Contract #: 04-0120F4Cty: SF/ALA Rte: 80 PM: 13.2/13.9File #: 69.28**WELDING INSPECTION REPORT****Resident Engineer:** Pursell, Gary**Address:** 333 Burma Road**City:** Oakland, CA 94607**Report No:** WIR-004407**Date Inspected:** 29-Oct-2008**Project Name:** SAS Superstructure**OSM Arrival Time:** 1400**Prime Contractor:** American Bridge/Fluor Enterprises, a JV**OSM Departure Time:** 2300**Contractor:** Zhenhua Port Machinery Company, Ltd (ZPMC), Changxing Island **Location:** Shanghai China**CWI Name:** Zhu Zhong Hai**CWI Present:** Yes No**Inspected CWI report:** Yes No N/A**Rod Oven in Use:** Yes No N/A**Electrode to specification:** Yes No N/A**Weld Procedures Followed:** Yes No N/A**Qualified Welders:** Yes No N/A**Verified Joint Fit-up:** Yes No N/A**Approved Drawings:** Yes No N/A**Approved WPS:** Yes No N/A**Delayed / Cancelled:** Yes No N/A**Bridge No:** 34-0006**Component:** Tower/OBG**Summary of Items Observed:**

89M Mock-up

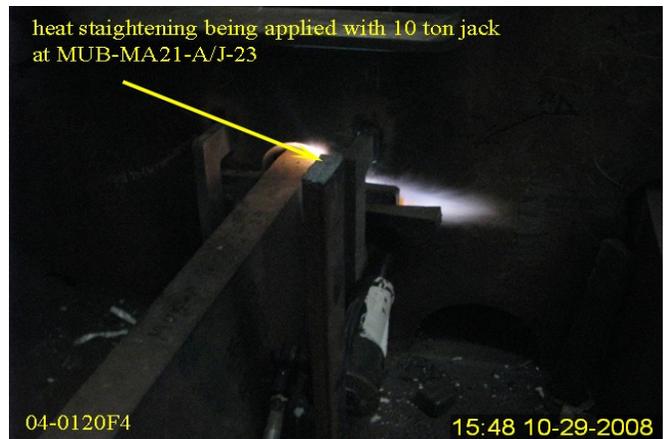
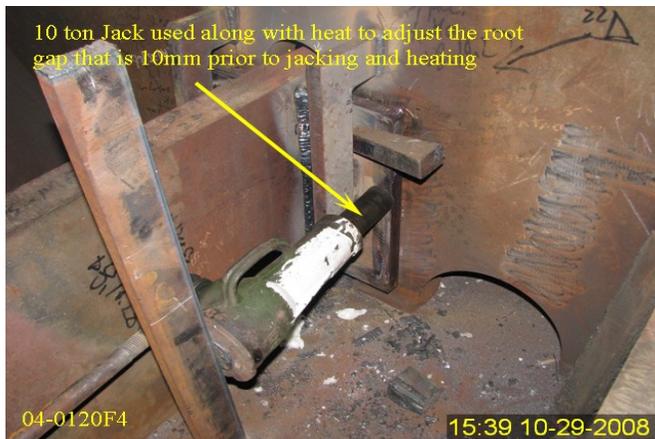
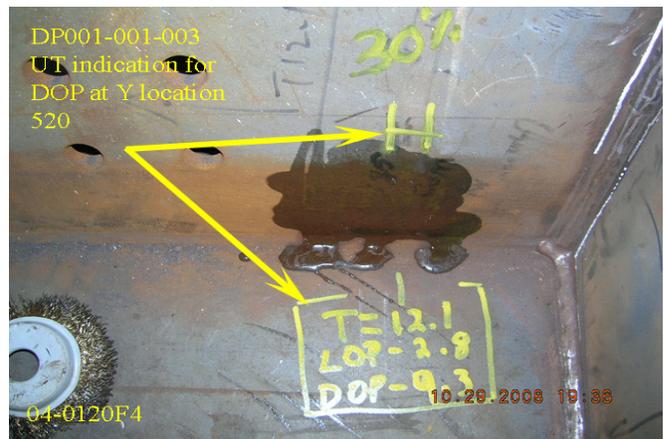
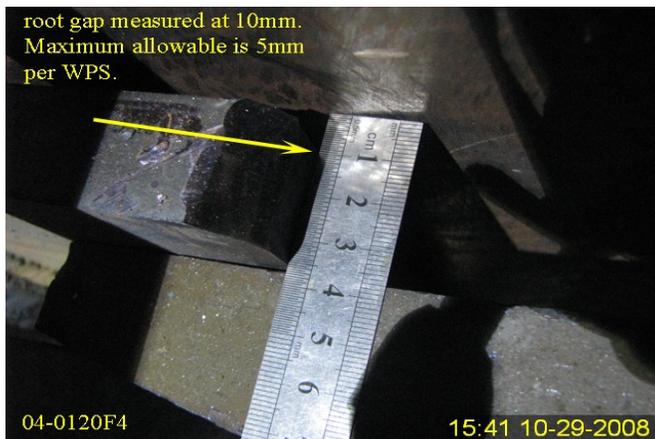
Caltrans QA Inspector observed that ZPMC were performing heat straightening with a 10 ton jack at MUB-MA21-A/J-23 due to the root gap being 10mm. Upon the arrival of this QA inspector it was observed that ZPMC had placed the 10 ton jack in place and was using their typical torch set up to heat the fit lug from the back side through the diaphragm while applying pressure from the jack. This process will also take place for the MUB-MA21-A/J-62 fit lug joint due to the root gap also being out of tolerance as outlined within the new weld trial WPS. ZPMC had informed this Caltrans QA inspector that no welding would take place today on swing shift due to inclement weather and the above process for the root gap and that tomorrow 10/30/08 they will weld the fit-lug to diaphragm fillet welds with the new trial procedure ABF-WPS-D15-F1202A for the Shielded Metal Arc Welding (SMAW) process. The welding electrode will be E7018-C3L, 3.2mm diameter. At this time there is no PQR to back up this WPS; Caltrans was informed that if this weld trial passes ABF and ZPMC will run the PQR for this WPS. Also noted on the new WPS is the root gap tolerance which states for plates and shapes less than 75mm the root gap shall not be greater than 5mm. If the root gap is greater than 2mm that weld size shall be increased the same amount as the root gap up to 5mm. Example 4mm root gap the weld size for a 22mm fillet weld will be increased to 24mm (+2mm). This QA Inspector was also informed by ABF that after the welding of the diaphragm to fit lug with the SMAW high nickel electrode tomorrow 10-29-08, that if these welds pass with no cracking or controlled heat cool down problems they will continue at this same location with 2 more trials to achieve 3 consecutive acceptable results. Below are digital photos of the jacking and root gap for the fit-lugs.
